RETAINING ROD NUT FOR BATTERY BOX COVER

Prevost vehicles

DESCRIPTION

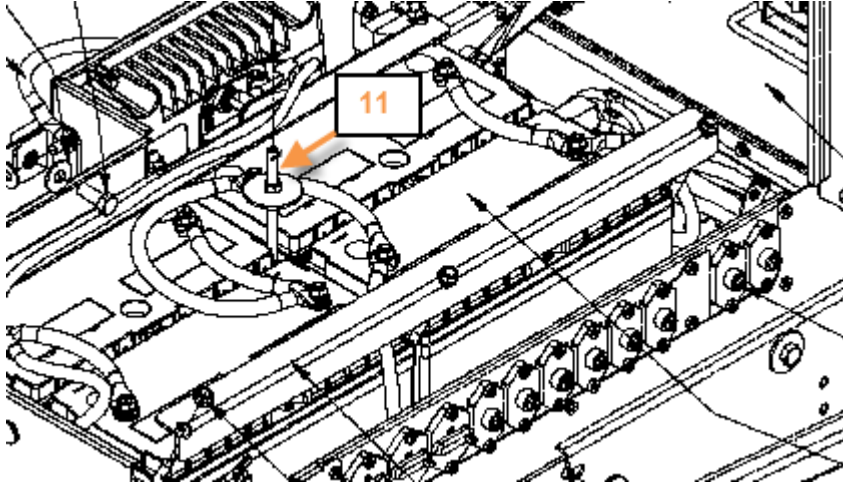
- 1) In the vehicle battery compartment, unscrew the battery box cover retaining nut and remove the cover (parts # 1 and # 10 below).

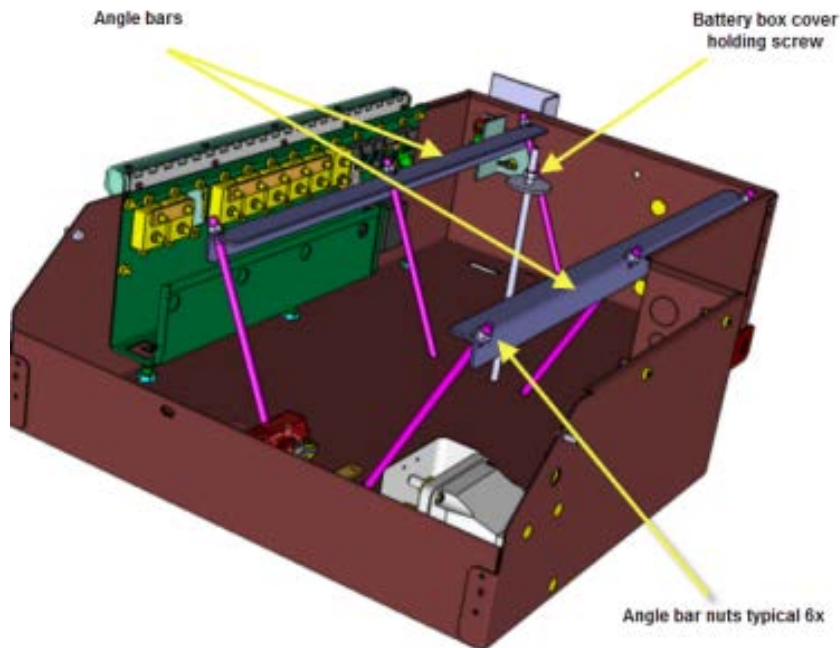
- 2) Unscrew the cover retaining rod from the battery box (part # 11 in the figure below).

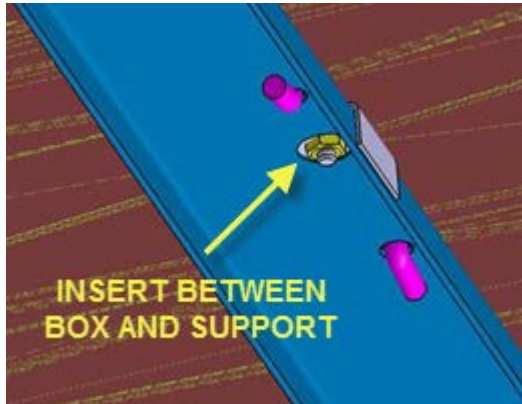
- 4) Using a pry bar or other suitable means, lift the bottom of the battery box away from the support to gain access to the welded hex nut used to secure the retaining rod to the bottom of the battery box.

- 5) With the help of a sharp chisel, remove the welded hex nut from the underside of the box.

- 6) Insert the angled tab nut between the support and the battery box (see drawing).

DETAILS OF THE ANGLED TAB NUT (All dimensions in millimeters)

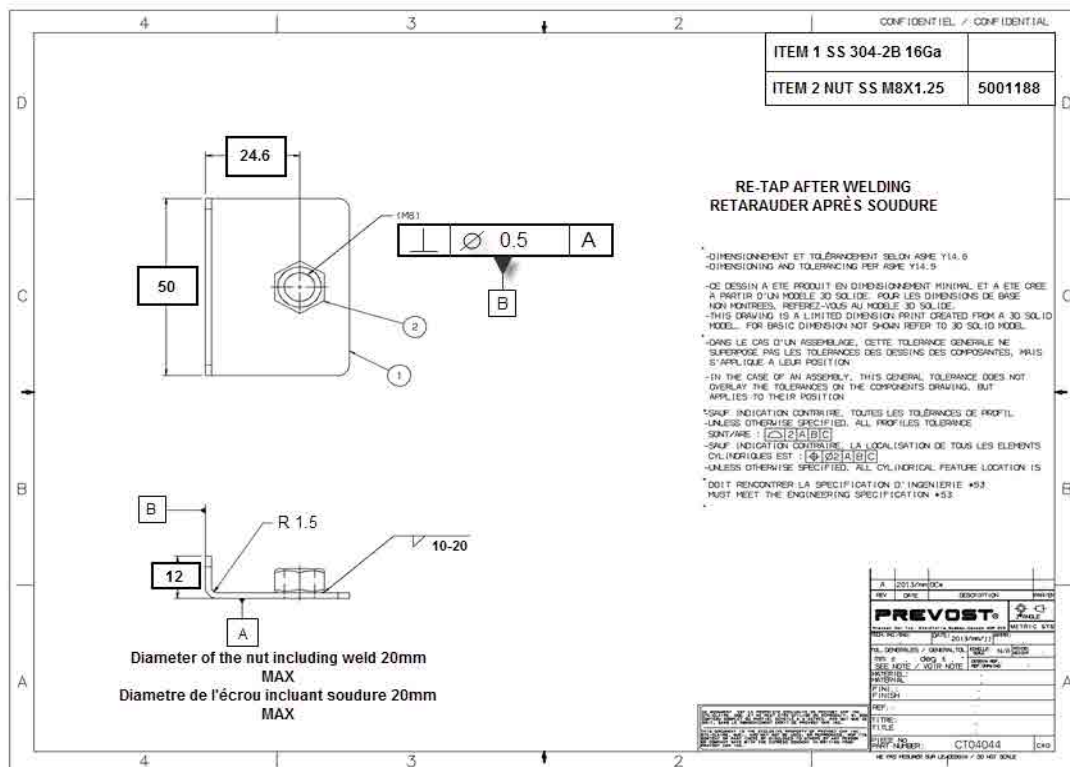
On the vehicles affected by this bulletin, the spot welded hex nut that holds the battery box cover retaining rod may break loose. Follow the procedure described below to repair vehicles.

- 7) Tighten back the six (6) hex nuts securing the angular battery retaining bars.
- 8) Tighten the battery cover rod into position. (Use Loctite Blue #242 or equivalent medium strength threads locker on the bottom threads).
- 9) Put back and tighten the box cover.
